Cabinetry in the built-in environment — Commercial and domestic

Amendment No. 1

Revised text amendment

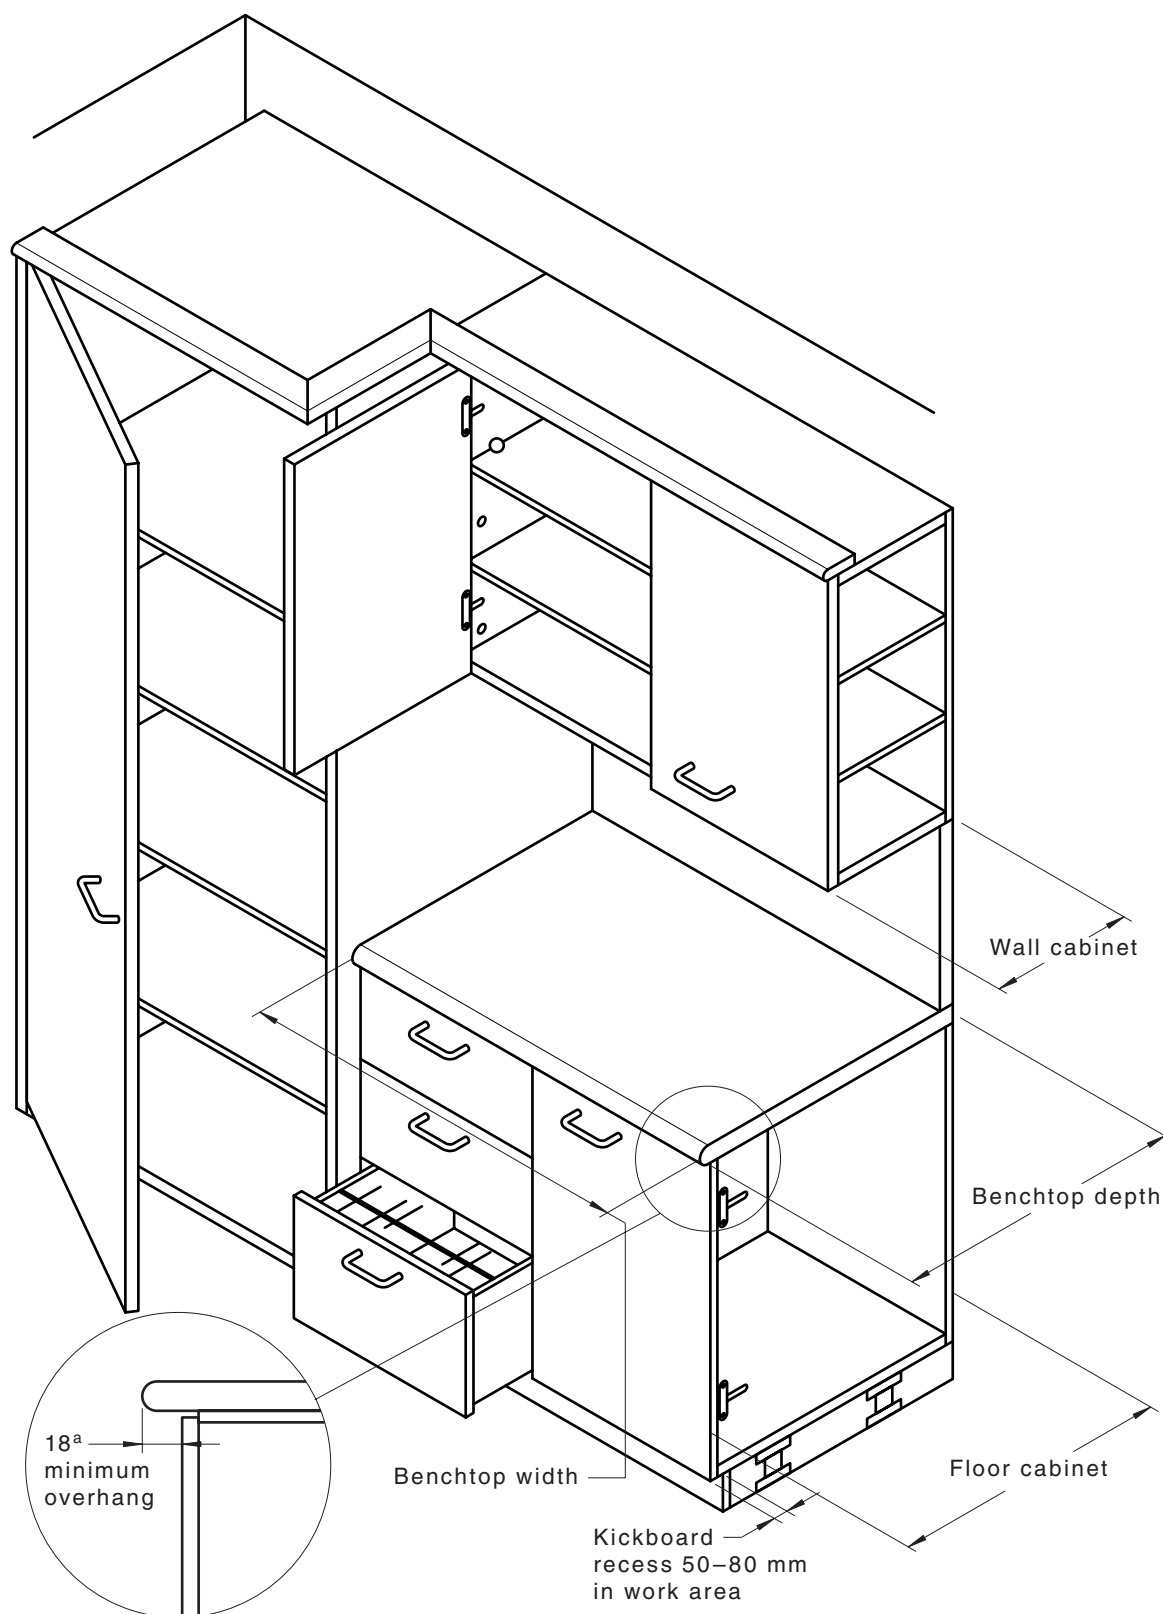
Cl A12	<i>Delete</i> text and <i>replace</i> with the following: Wall cabinets incorporating appliances that require housing deeper than 600 mm should be negotiated between the supplier and purchaser. NOTE: Clause of 11.3 outlines requirements for the safe installation of wall cabinets.
Figure A2	<i>Delete</i> figure and <i>replace</i> with the following:

^a These are preferred dimensions

NOTE For information on wall cabinets, benchtops and floor cabinets, see Clauses A10 to A11.
